U.S. Army Corps of Engineers

Assabet River Sediment Management Plan

CDM Response to Mass DEP Comments on the Draft Sediment Management Plan

Figure 2-4: Dredging Extents for Gleasondale Impoundment

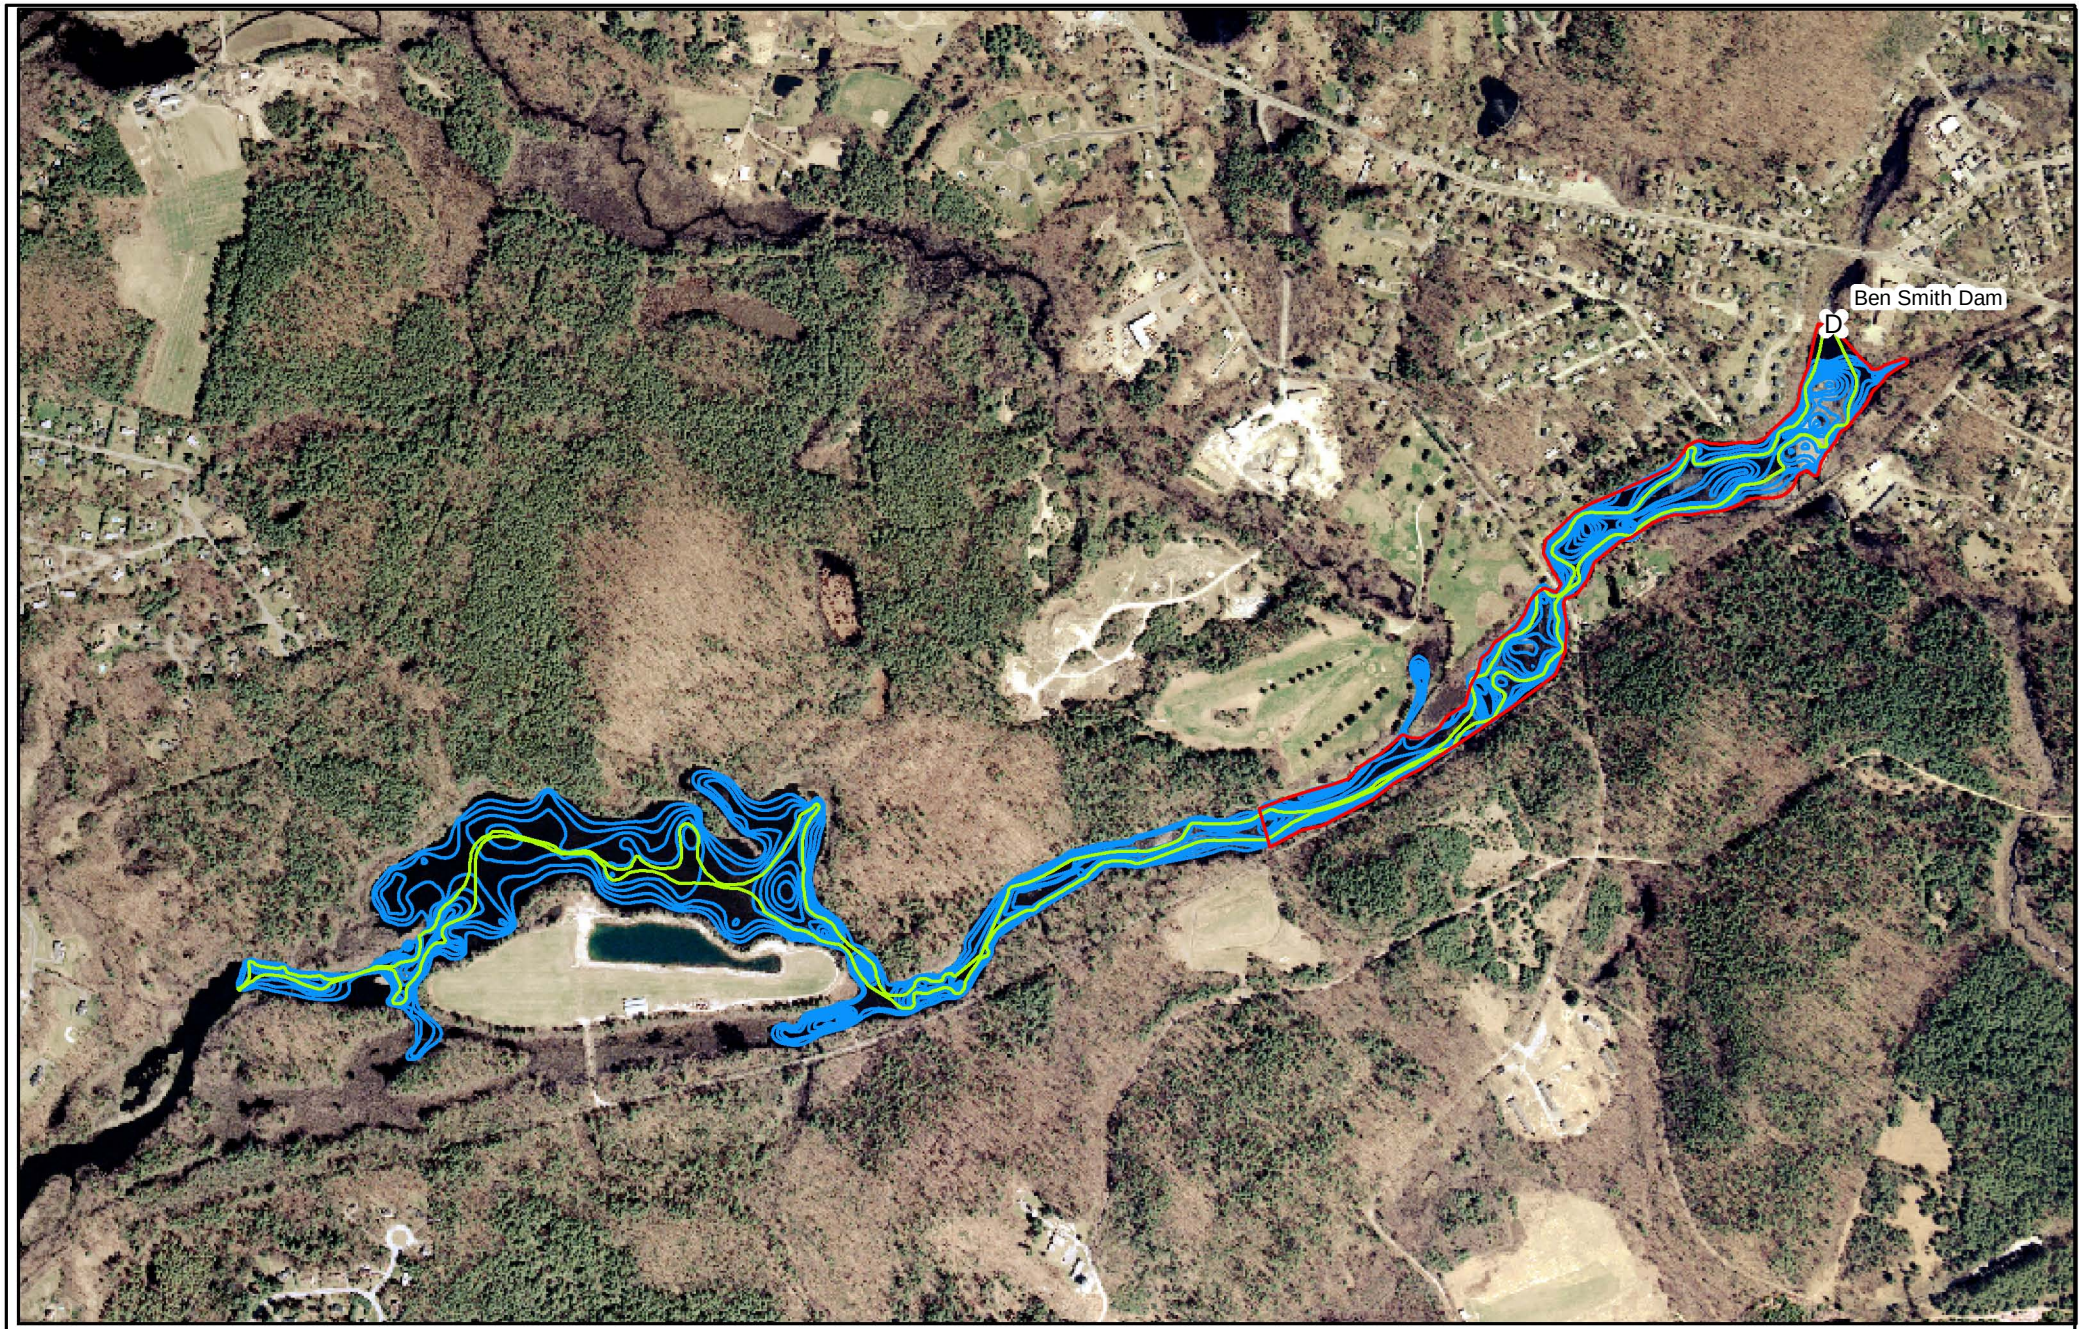
DEP Comment	CDM Response
Figure 2.4 indicates a considerable upland/wetland area in Gleasondale Impoundment that may have to be dredged. The reasoning for dredging this particular area should be presented and clarification should be made that any dredging would have to go through normal permitting processes such as MEPA and the Wetland's Protection Act to achieve final approval.	The dredging boundaries as shown are approximate and were developed based on results of the HEC-6 modeling. Further studies are required during subsequent phases of this work to determine actual dredging boundaries.
It would be helpful if the summary USGS sediment data tables in Section 2 were flagged somehow to indicate when parameters were over the threshold limits.	The parameters that were above the threshold are highlighted in the revised plan. However, it should be noted that the testing of the dewatered and processed sediment may not show similar results.
